CITY OF ALBUQUERQUE

June 7, 2023

**RE: Lot 6 – 3151 Bridge St. SW
Grading and Drainage Plan
Engineer's Stamp Date: 05/16/23
Hydrology File: L11D067D**

GRADING & DRAINAGE PLAN

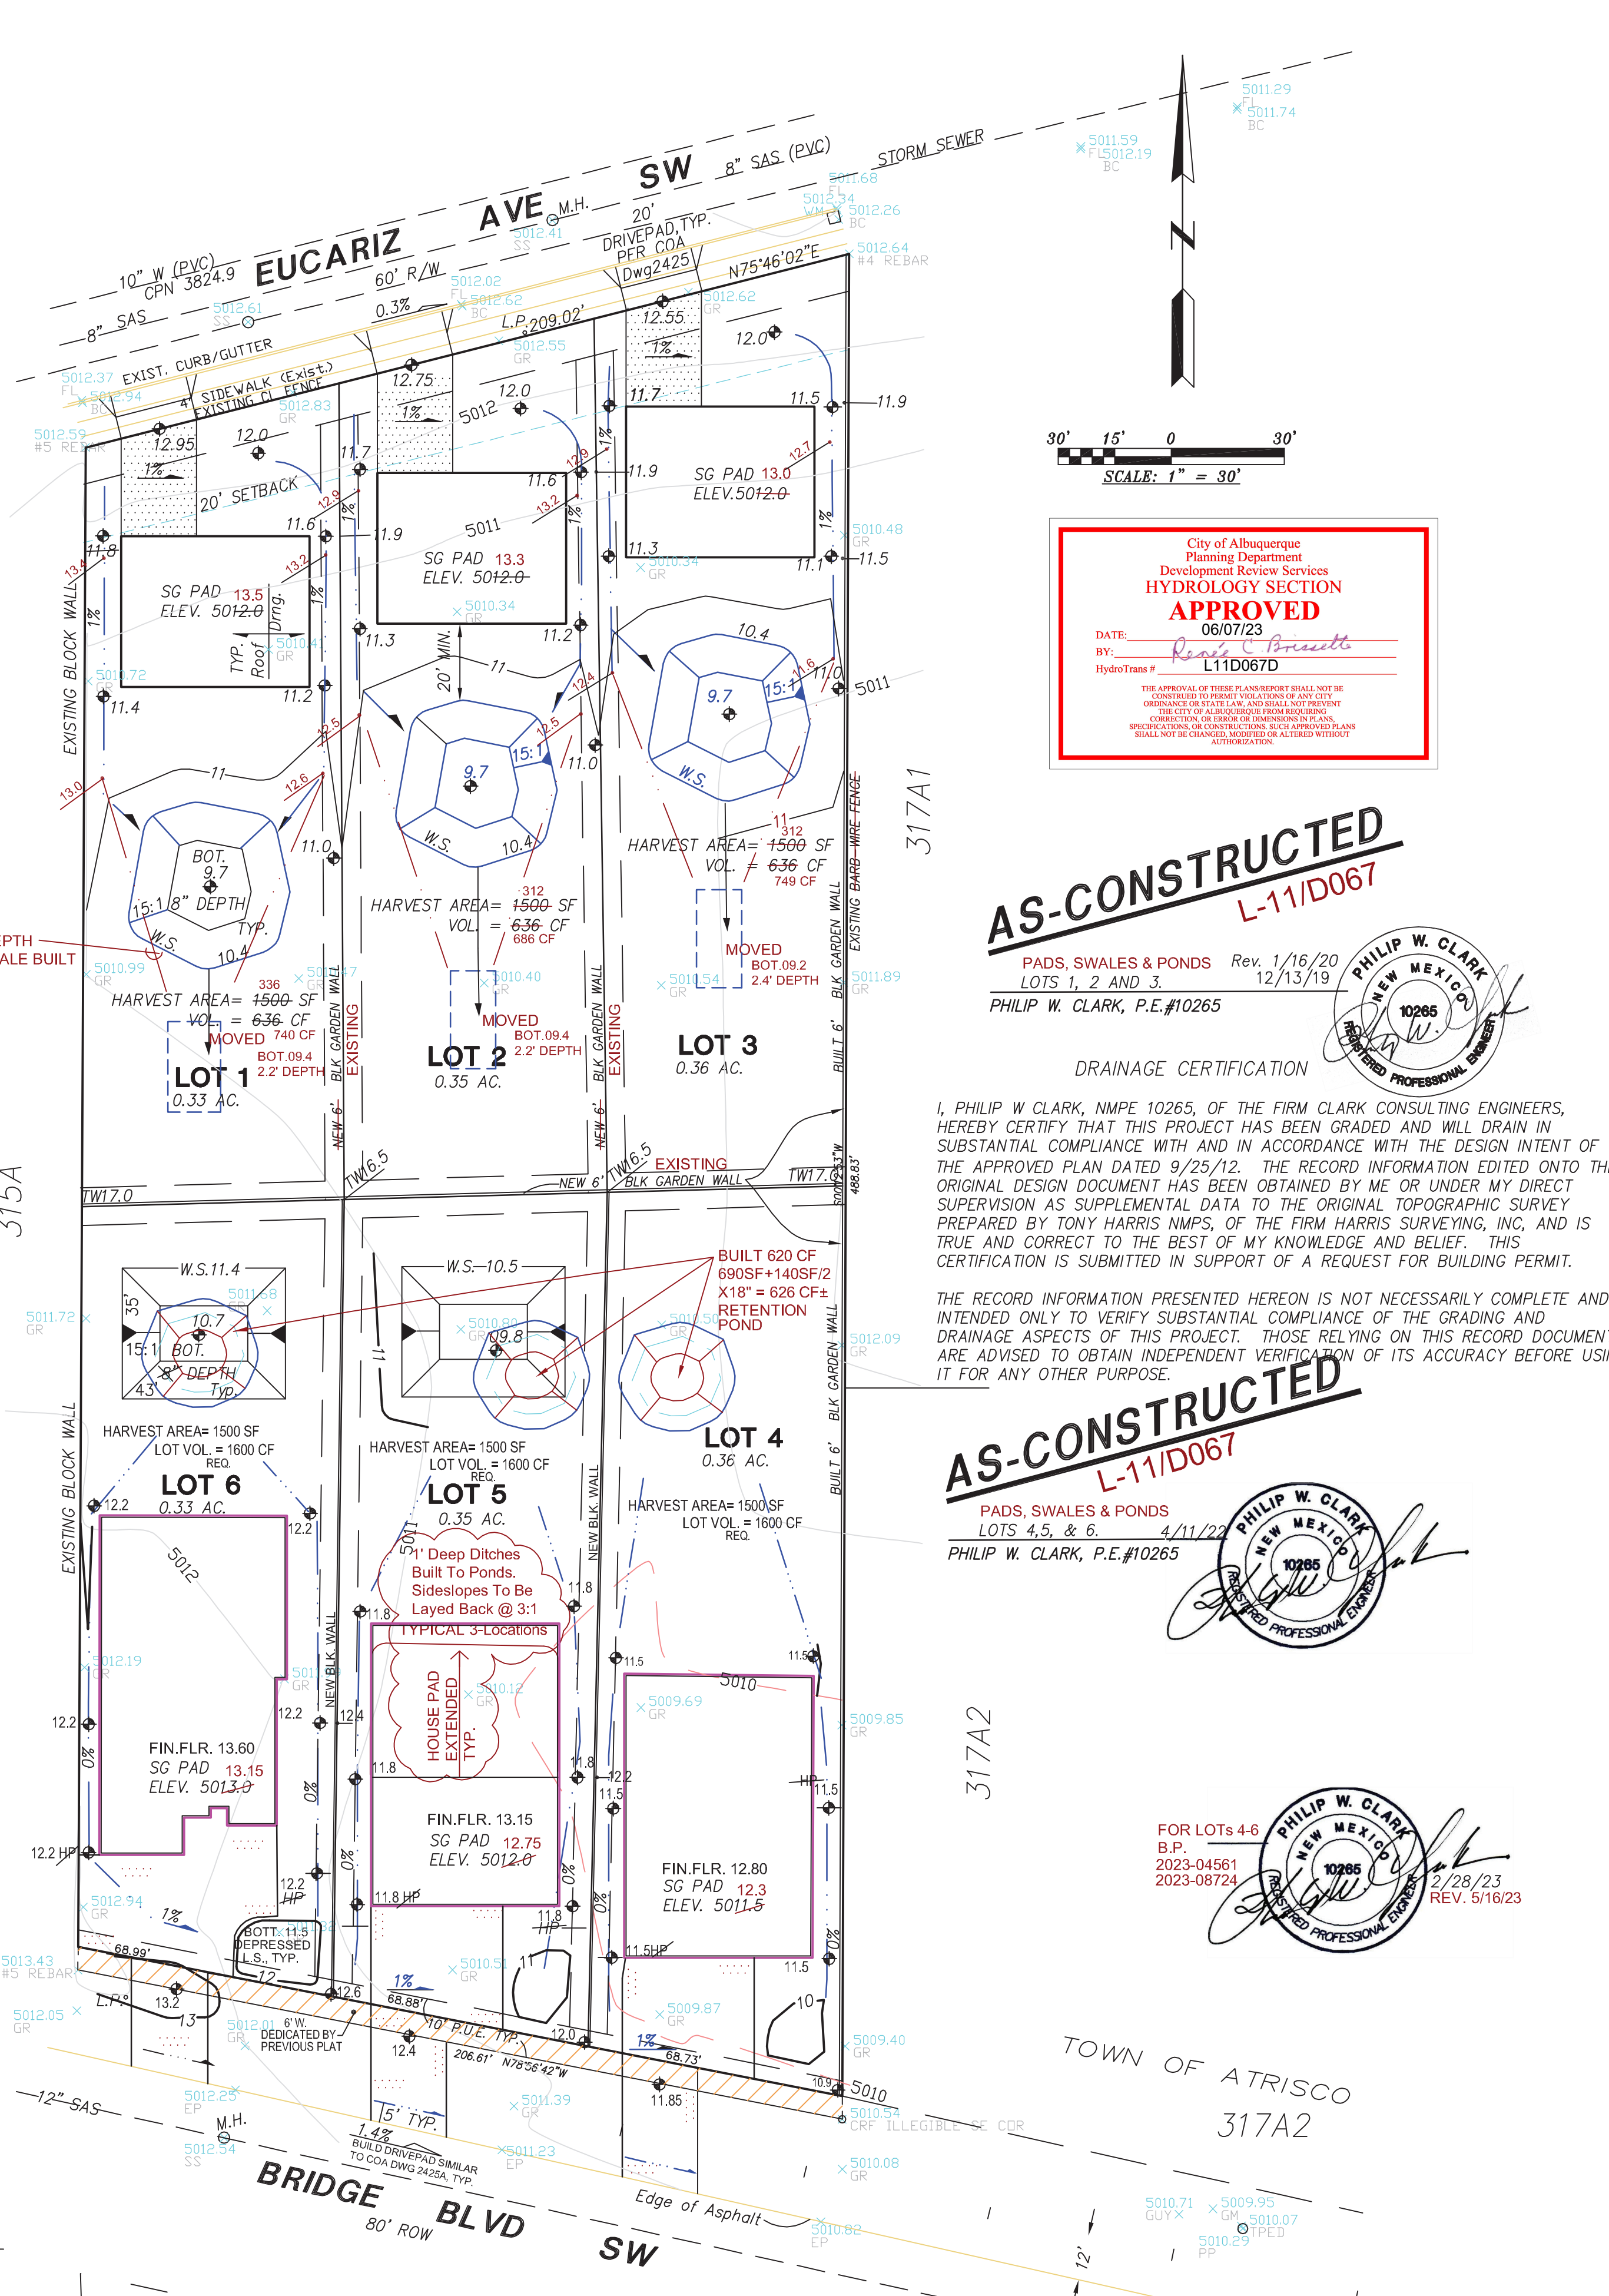
Based upon the information provided in your submittal received 05/17/2023, the Grading and Drainage Plan is approved for Building Permit and Grading Permit. **Since this site has already been disturbed and graded, a pad certification is not needed for this project.** Please attach a copy of this approved plan in the construction sets for Building Permit processing along with a copy of this letter.

1. Engineer's Certification, per the DPM Part 6-14 (F): Engineer's Certification Checklist For Non-Subdivision is required.
